Subject: Duke Energy Corporation
Oconee Nuclear Station - Units 1, 2, and 3
Docket Nos. 50-269, 50-270, and 50-287

Revisions to Topical Report DPC-NE-3003 In Support of
Steam Generator Replacement
Response to NRC Staff Request for Additional
Information

Duke Power Response To Request For Additional Information

DPC-NE-3003 Revision 1 “Mass and Energy Release and Containment Response Methodology”

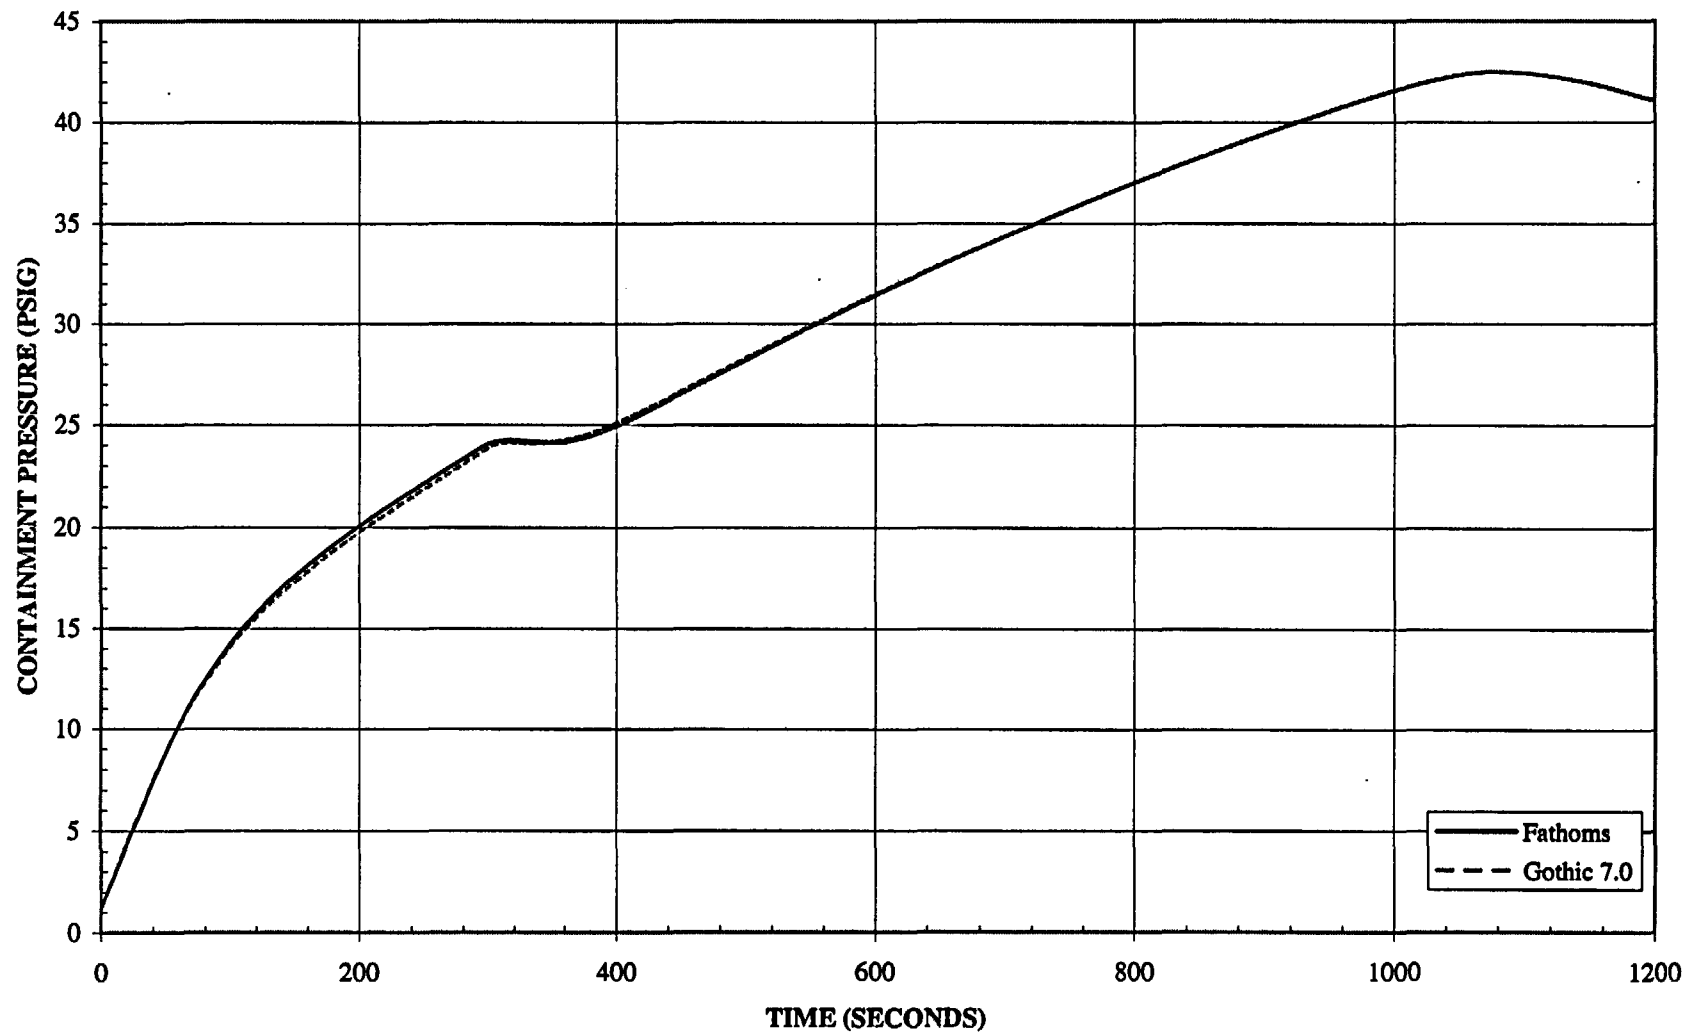
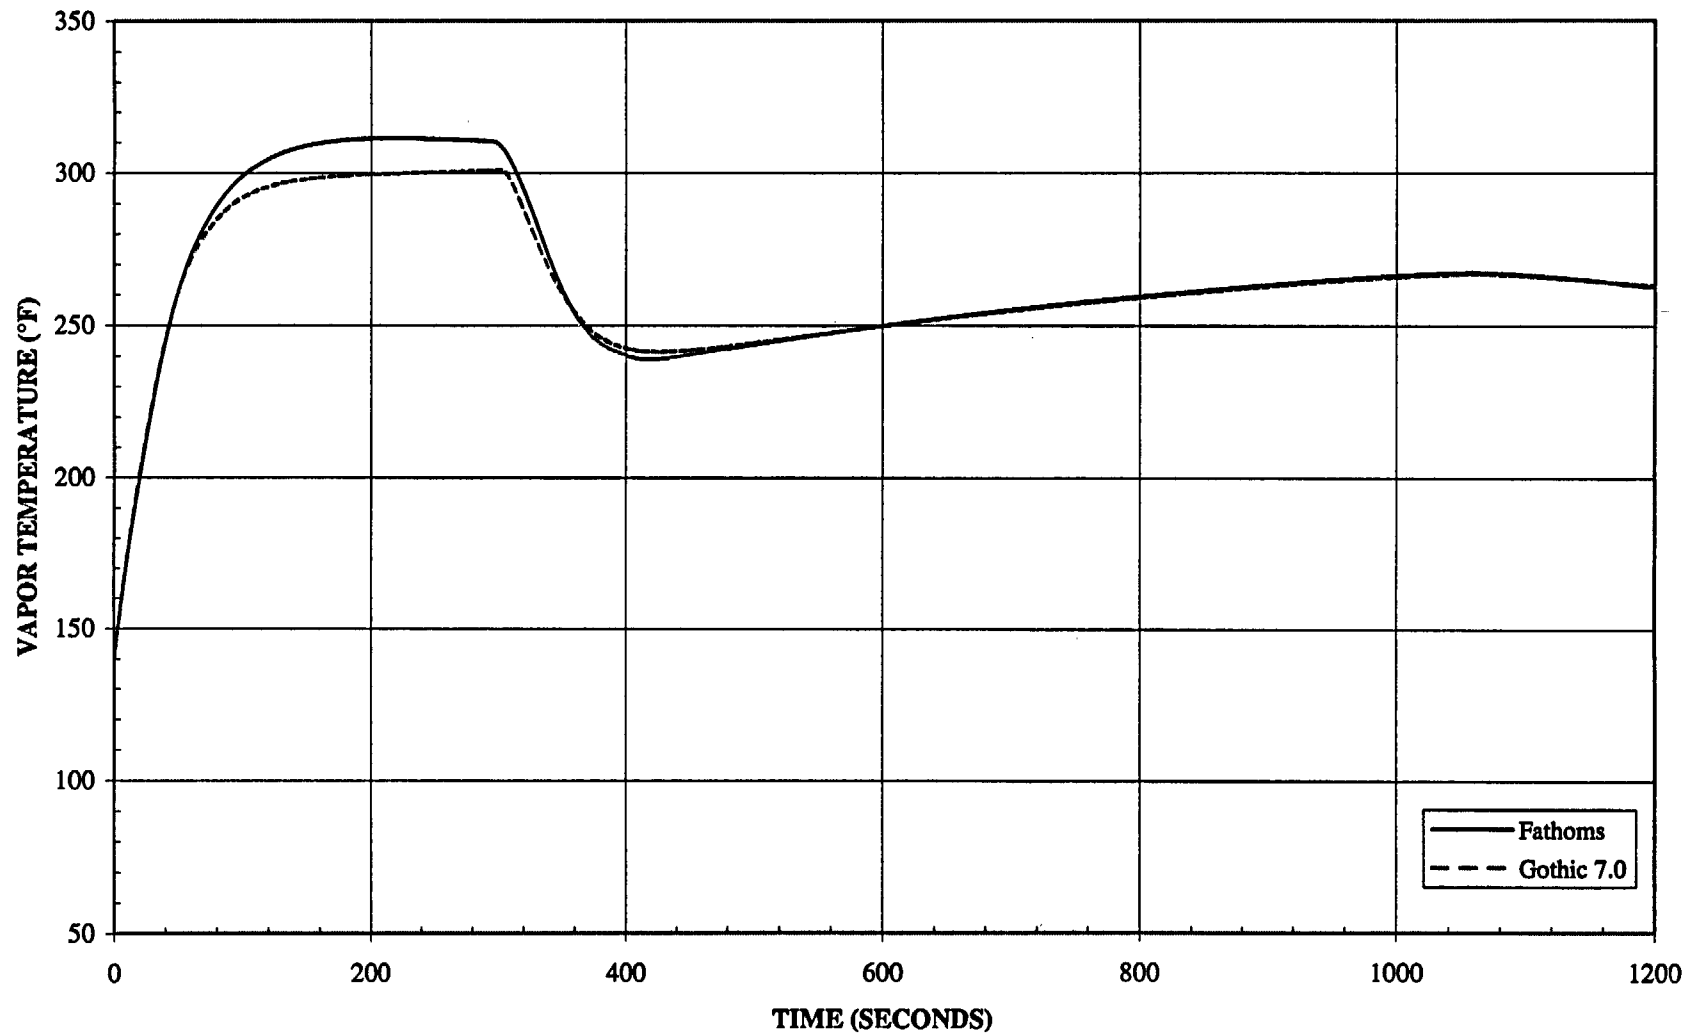
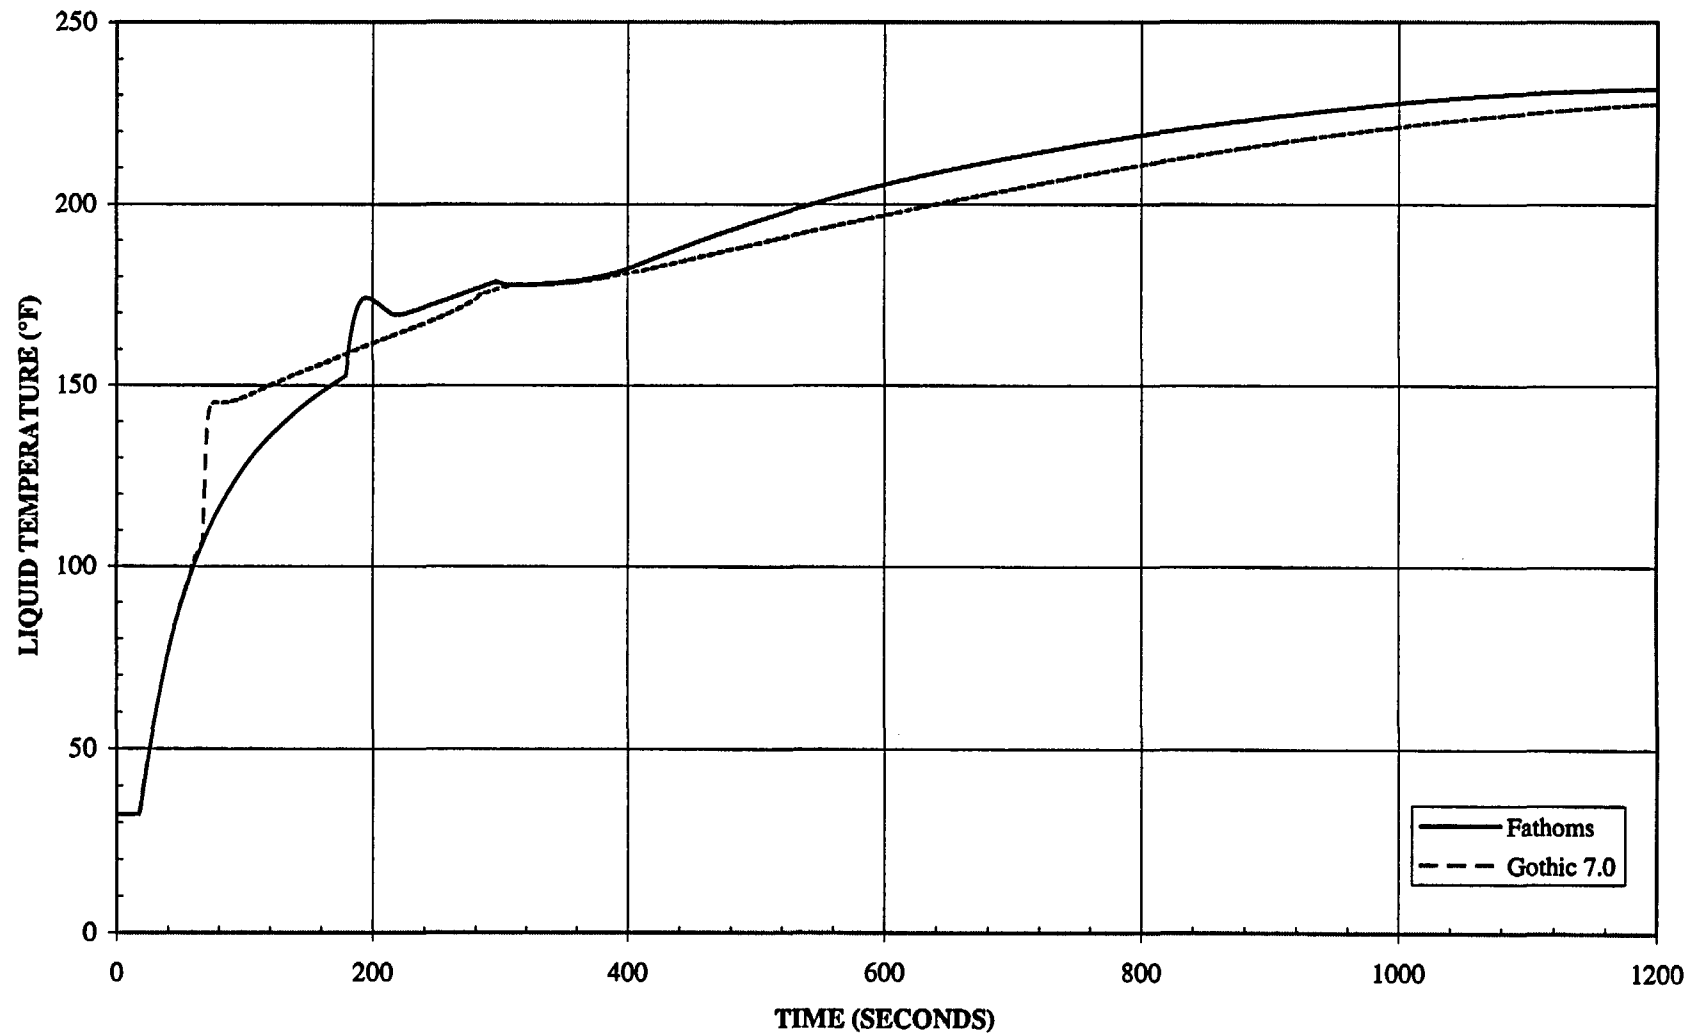
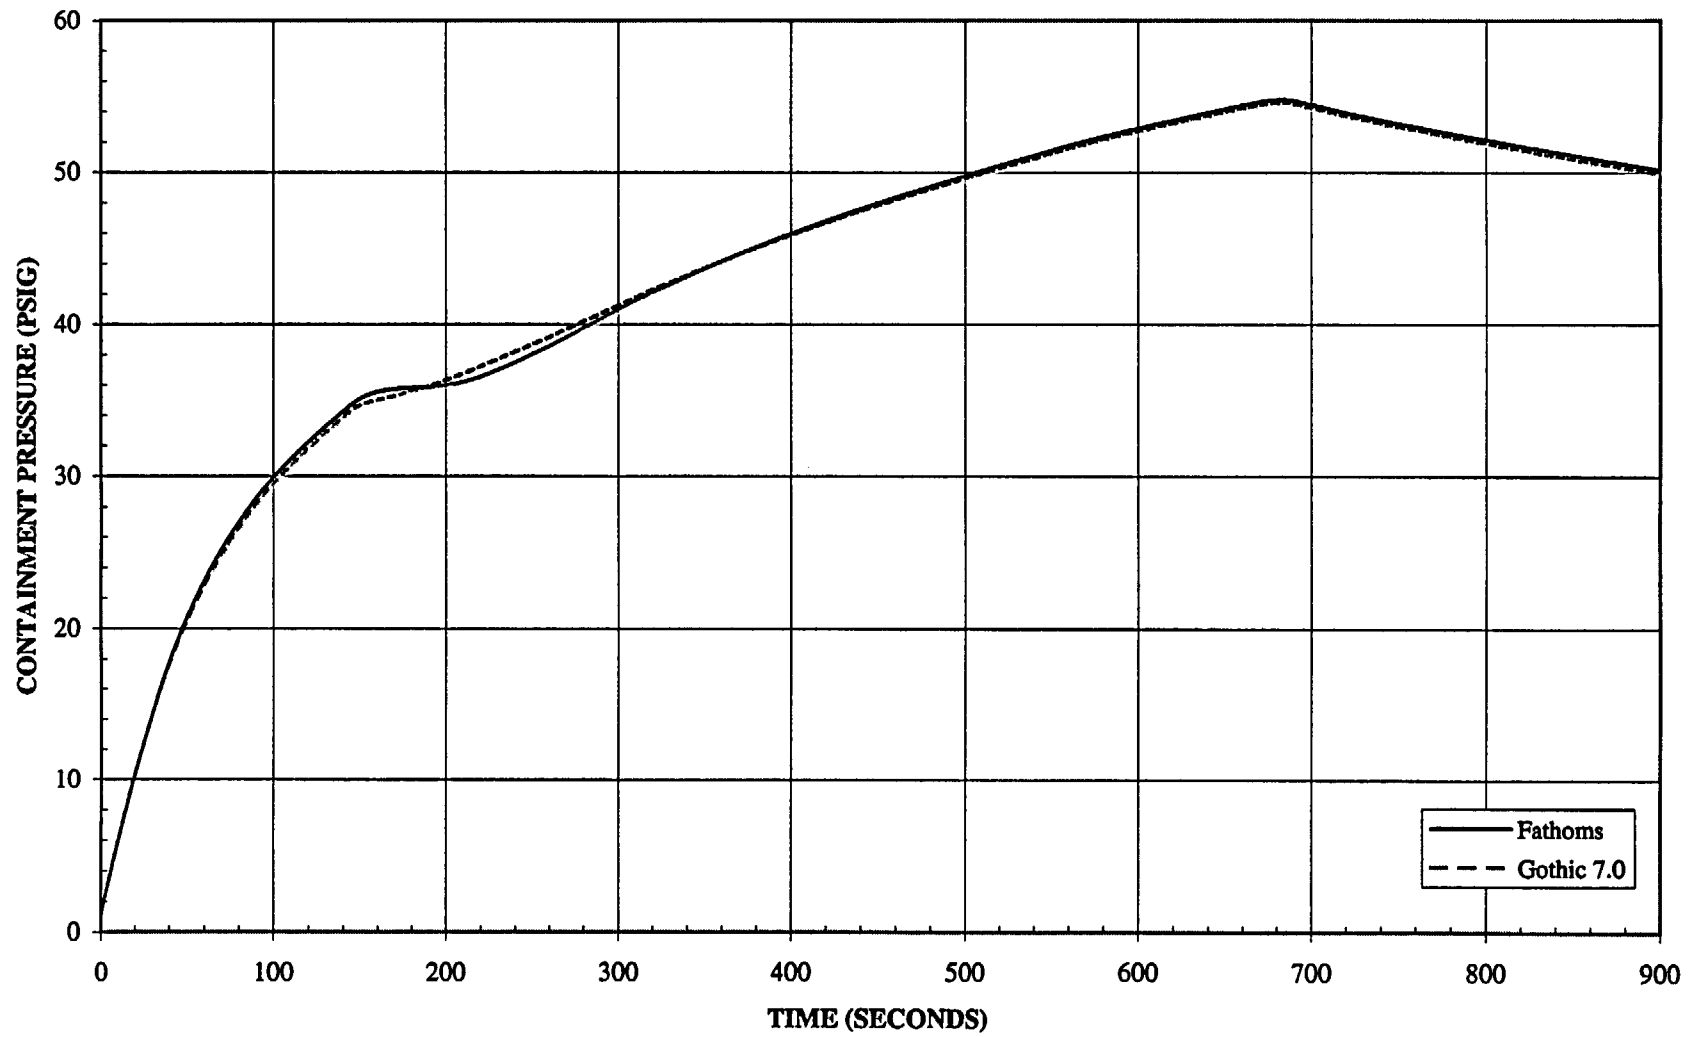
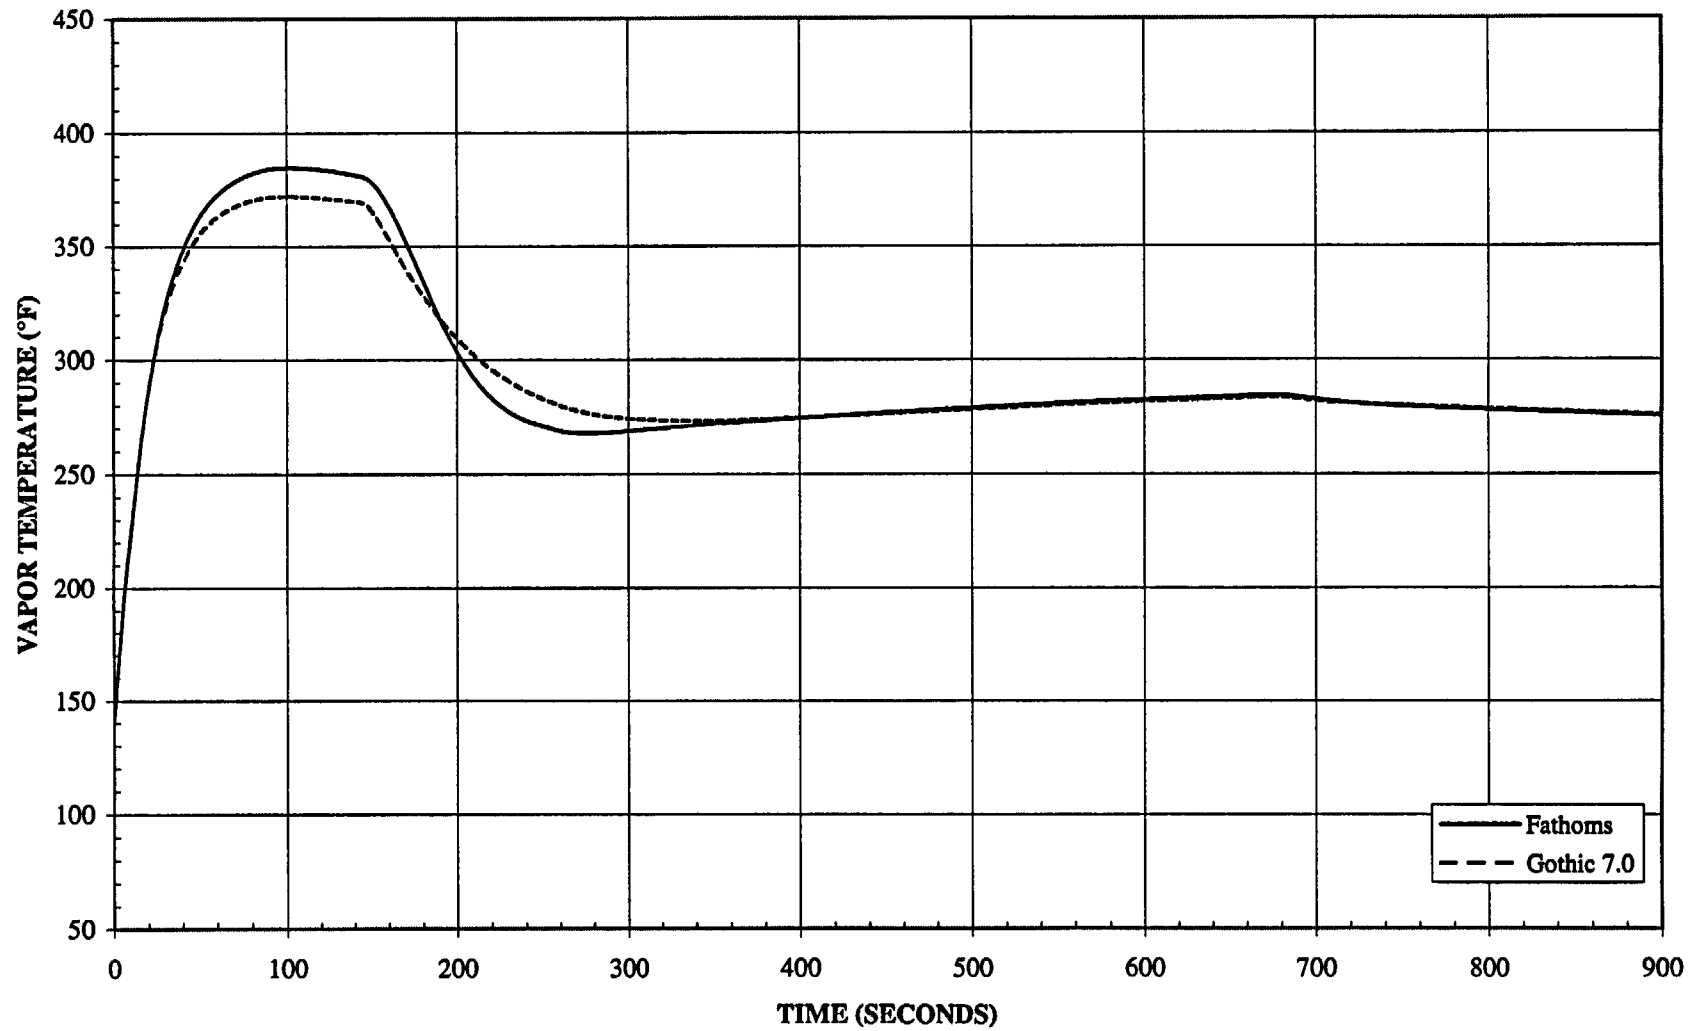
14. Show that GOTHIC and FATHOMS calculations result in the same pressures, temperatures, sump temperatures, etc. for the design basis LOCA and main steam line break events. If they do not, explain differences in terms of the differences in models between the two codes. (See Question 1.)

Response: Refer to the response to Question #3 for LOCA. The results of the 6 code comparison analyses for the main steam line break are given in Table 14-1 and the figures that follow. The containment response following a main steam line break event for the ROTSG was performed to compare the results from FATHOMS 2.4 and GOTHIC 7.0. In general, the pressure and vapor temperature responses are very similar. GOTHIC 7.0 predictions for peak pressures are slightly lower on the smaller break sizes (~0.3 psi) and slightly higher for larger break sizes (~0.95 psi). The peak vapor temperature responses predicted by GOTHIC 7.0 overall are slightly lower (~12°F). For larger break sizes, the higher pressure predicted by GOTHIC 7.0 may be attributed to additional steam generation from the improved interface heat and mass transfer models and from the drops that are generated due to dripping. The slightly lower pressure for smaller break sizes may be attributed to additional droplets in the atmosphere. The slightly lower vapor temperature and liquid temperature in GOTHIC 7.0 for all break sizes may be attributed to additional droplets in the atmosphere also. This effectively increases the heat capacity of the atmosphere and reduces the temperature rise for a given energy addition. As discussed in the responses to Questions #1 and #3, more liquid is predicted to remain in droplet form in GOTHIC 7.0 which results in less liquid mass in the sump. In addition, the lower sump temperature predicted by GOTHIC 7.0 may be attributed to the addition of the second energy equation for the drops and the improved heat and mass transfer models in GOTHIC 7.0.
